Addendum # 1

Bid Opportunity: ITT-2021-30 - Washington

WASHINGTON AVE SANITARY DETAILS			
Sheet Number	4 of 4	Project Number	Revision
0872.0071.02	D01	0	0

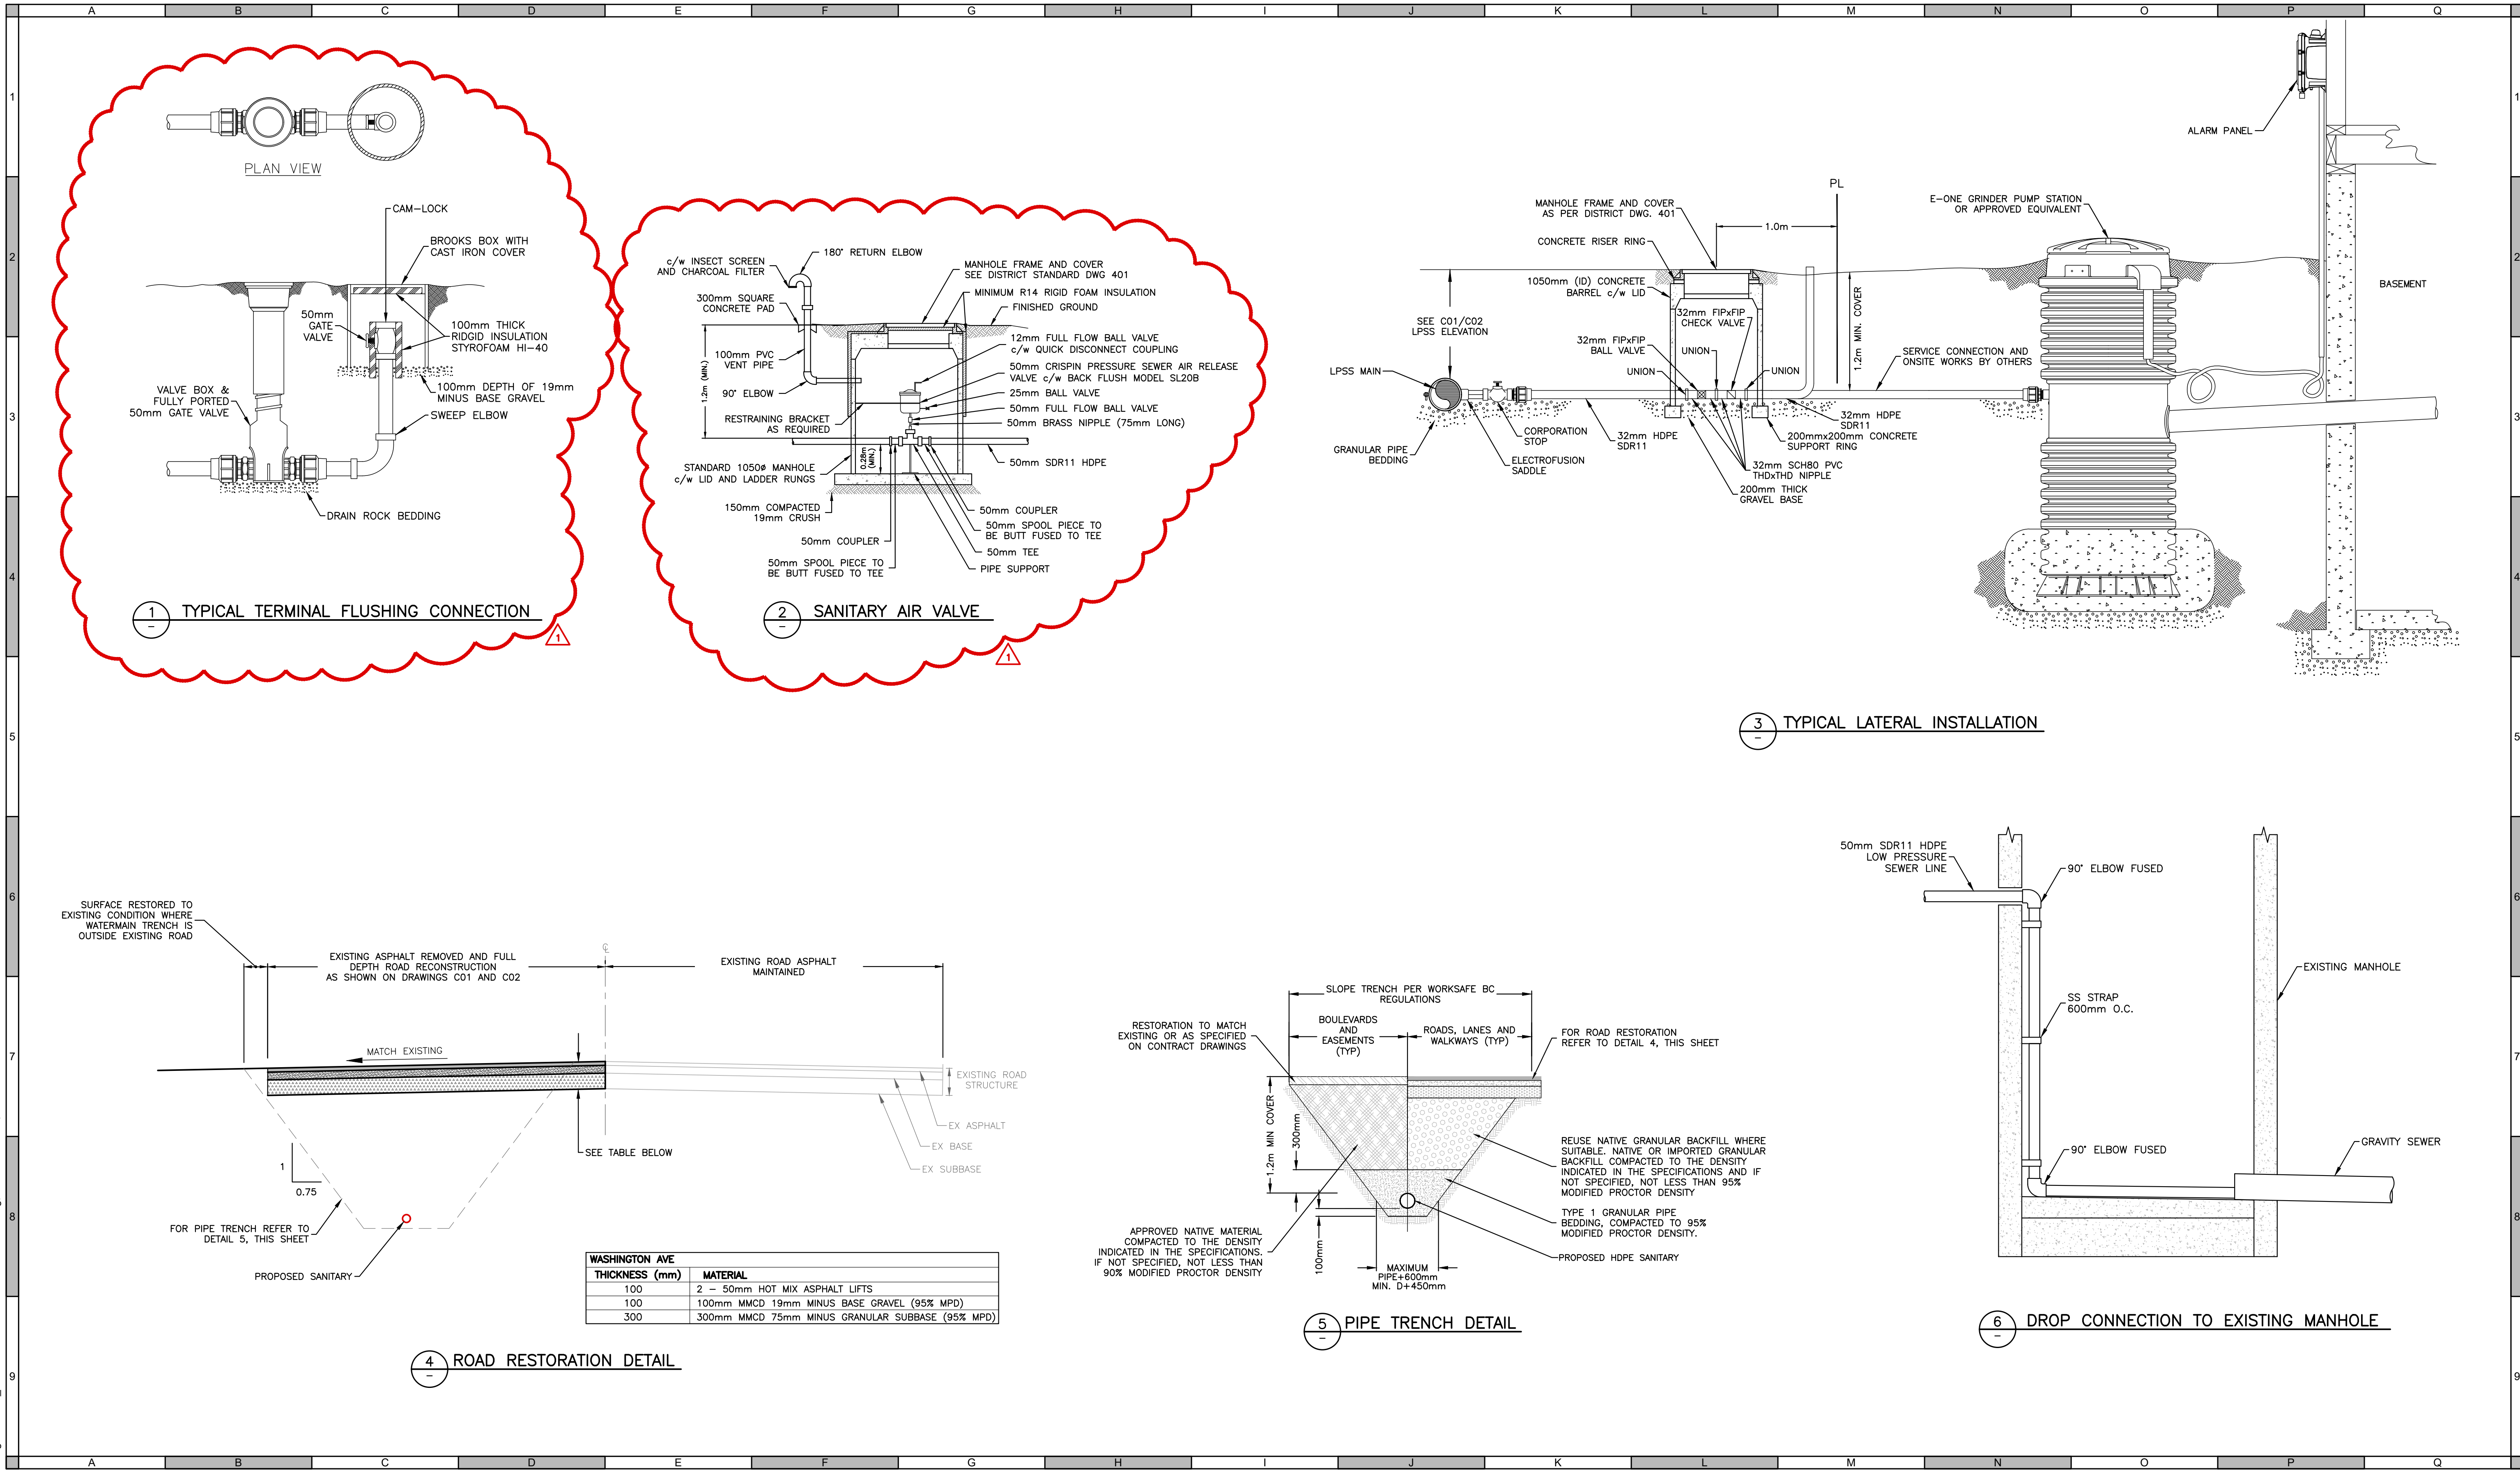
1. Delete drawing D01 (rev 0) and replace with attached drawing D01 (rev 01). Detail 1 Typical Terminal Flushing Connection and detail 2 Sanitary Air Valve have been revised. See Questions 1 and 2 in Responses to Bidders Questions below.

I would just like to confirm that on the terminal flush connection a 50mm ball valve is to be buried there? The access to this valve will make it difficult to turn off/on. A brooks box should not be used in a roadway, could this not all be put in a manhole?

There is no such item as a 2706 2x2" saddle. How would you like to come off the mainline for the sewer air valve?

Use a 50 mm gate valve with a square operating nut where the 50 mm ball valve is indicated in Detail 1 on sheet D01. Installation to be c/w an IC capped with a

Locking Nelson Type Box marked "Sewer." See District of Summerland Standard Drawings 409 for more info.

The Brooks Box must be H-20 rated. District of Summerland Standard Drawing 408 specifies a "305x508 Concrete Pull Box 37 Series Brooks Products Ltd."

Where the 2606 series product is indicated in Detail 2 on sheet D01, see the revised D01 (attached). The revision includes: a tee with spools and couplers. To be assembled then connected via butt fusion.
